## Appendix D

### Technical Advisory Committee and Stakeholder Advisory Committee Meeting Minutes

**Subject:** 052314-MCEA Schedule C Warden Avenue and Kennedy Road between Major Mackenzie Drive to Elgin Mills Road, in the City of Markham Technical Advisory Committee

# Low Impact Development (LID) Measures

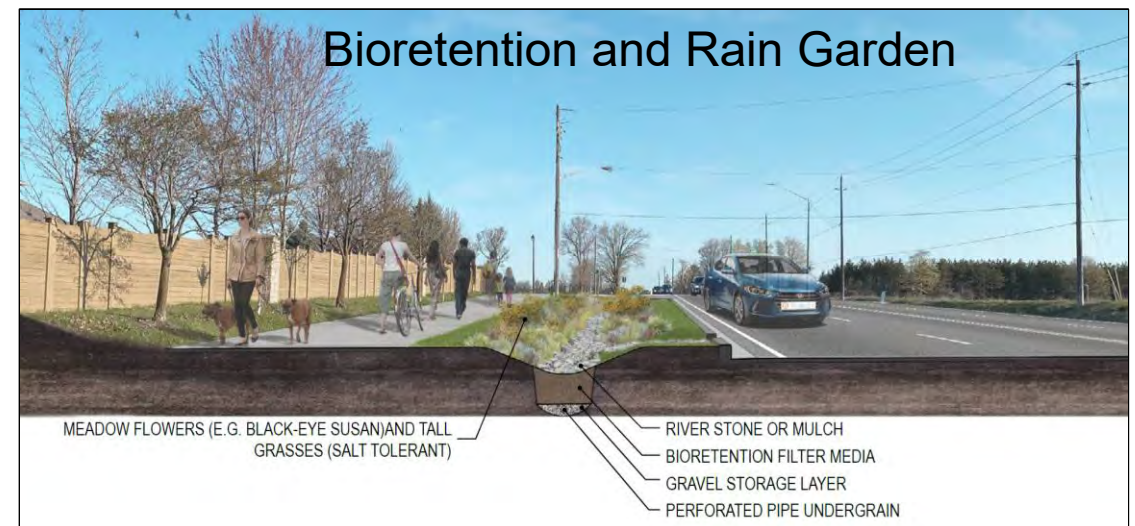
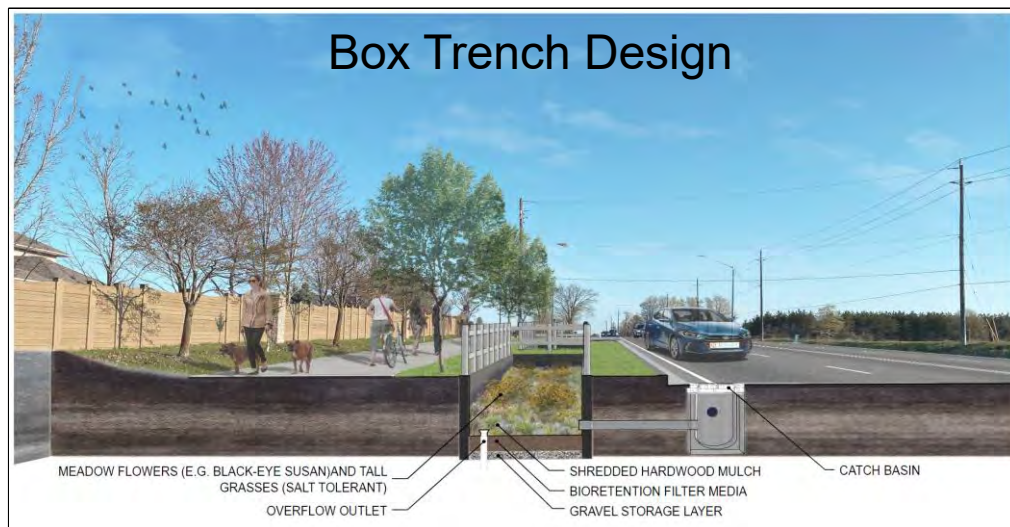
Feedback from TAC Meeting 1 (Jan 25, 2022)	How Feedback addressed
<b>If the road profile is raised, a backflow condition for stormwater should be considered</b>	As part of the stormwater management plan being prepared for these studies, a backflow condition will be considered.
<b>Impact of centre median on access for emergency service vehicles</b>	The Study Team is moving forward with a preferred design concept that includes a 1.0m marked centre median. This would be a painted feature, not raised.
Feedback from TRCA Meeting (Jan 27, 2022)	How Feedback addressed
Suggested geotechnical investigation be included in EAs.	A geotechnical investigation was completed in support of the two EAs.
Inquiry if drainage hydrology would be assessed.	Clarification provided in Meeting Minutes: drainage hydrology will be included in the stormwater management assessment.
Ensure that hydraulics of the study area are investigated when proposing to revise (raise) road profile. Ensure that staff have thoroughly reviewed the Markham FUA for sizing of storm water ponds, etc.	The Study Team will incorporate this feedback into the stormwater management assessment.
